EXD082 – Section One Local Plan – Matter 6. Further questions.

Response from Wivenhoe Town Council

Figure 19 Changes at Greenstead roundabout

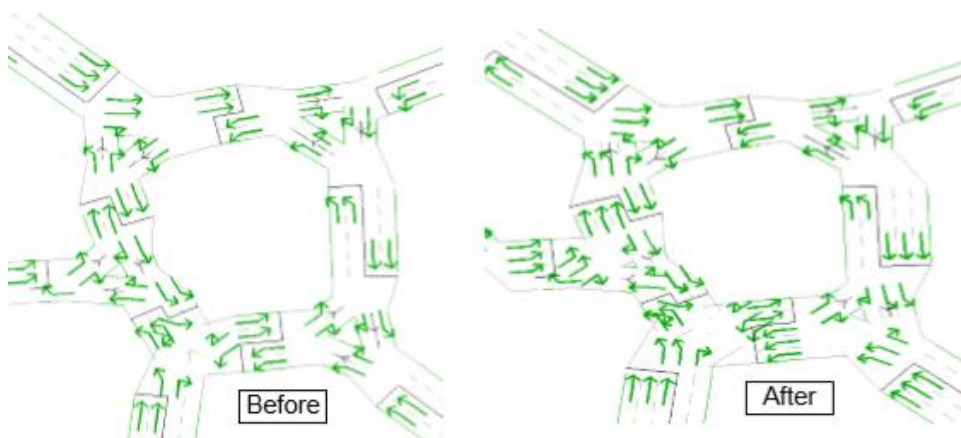
If we have orientated this map correctly the extension to 3 lanes at entry to the right of "After" is Clingoe Hill. If you follow the journey round (either way – it is a magic

roundabout) each three lane hits a mini-roundabout and a reduction to 2 lanes. Precisely the factors that gridlock it currently and lead to it being over capacity. To the left of "After" is Colne Causeway. It is pedestrians crossing here to access the University that causes the AM peak overload. This road is also not wide enough to accept an additional lane. We would like much more information on this as it seems outrageous to base an entire BRT\RTS on this "improvement".
